IMPORTANT SAFETY RECALL

**Subject: Safety Recall Notice
NHTSA Recall No. 15V260**

Alternator Cable Securement Procedure

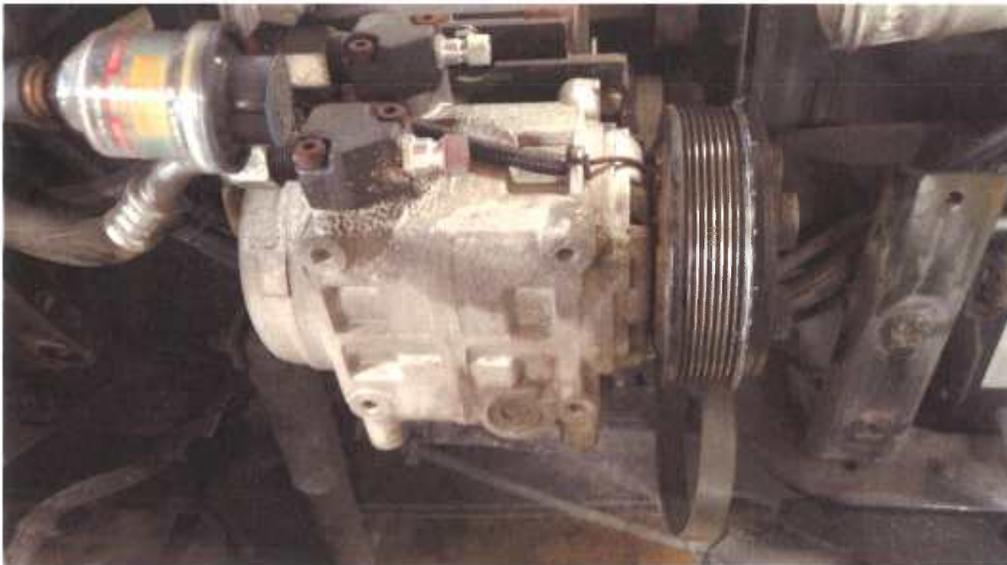
Vehicles subject to this recall campaign were manufactured with an alternator cable routed in an area, which over time, could rub through the cable insulation potentially causing an electrical short and possibly cause a fire. Eldorado has determined that this cable needs to be inspected and secured so it can not rub any sharp areas that might cut through the insulation of the cable and cause a short or the risk of a fire.

Step 1: Turn battery master disconnect switch to OFF position.

Step 2: Open hood and remove inner curbside fender liner.

Step 3: Remove charge air cooler hose located above aux. A/C compressor.

Step 4: Remove A/C belt.

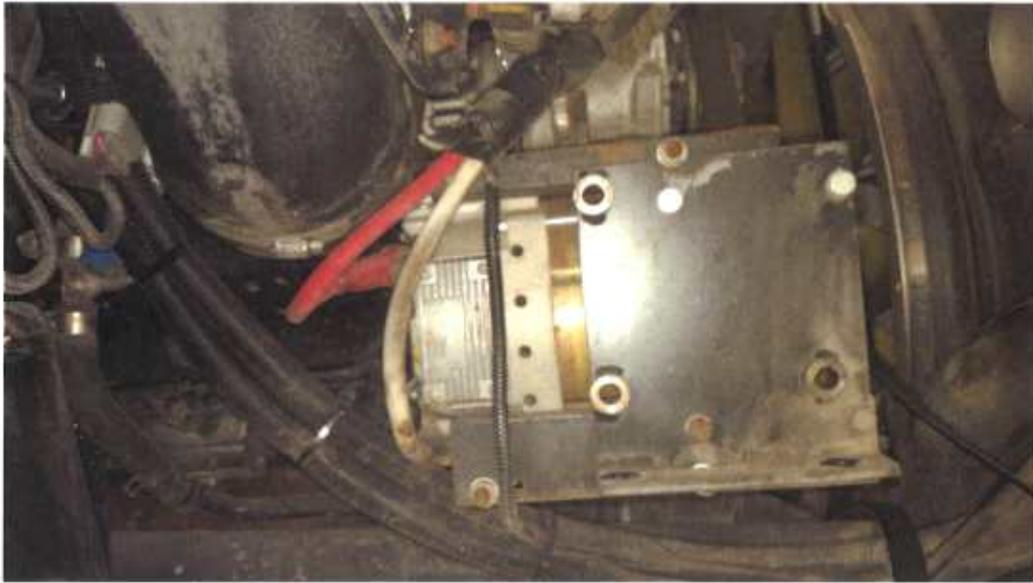
Step 6: Check condition of both alternator cables.

Step 5: Remove 5 bolts from A/C compressor and move compressor to a safe resting position. Note: Do Not Discharge A/C System.

Step 7: Install plastic loom around alternator cables and secure.

Step 8: Install cloth thermal covering and secure with tie strap provided.

Step 9: Drill hole through A/C bracket.

Step 10: Install insulated clamp around alternator cables and secure to A/C bracket using hole drilled from step 9.

Step 11: Make sure cables are not rubbing and re-install A/C compressor, A/C belt, Charge air cooler hose and fender liner.
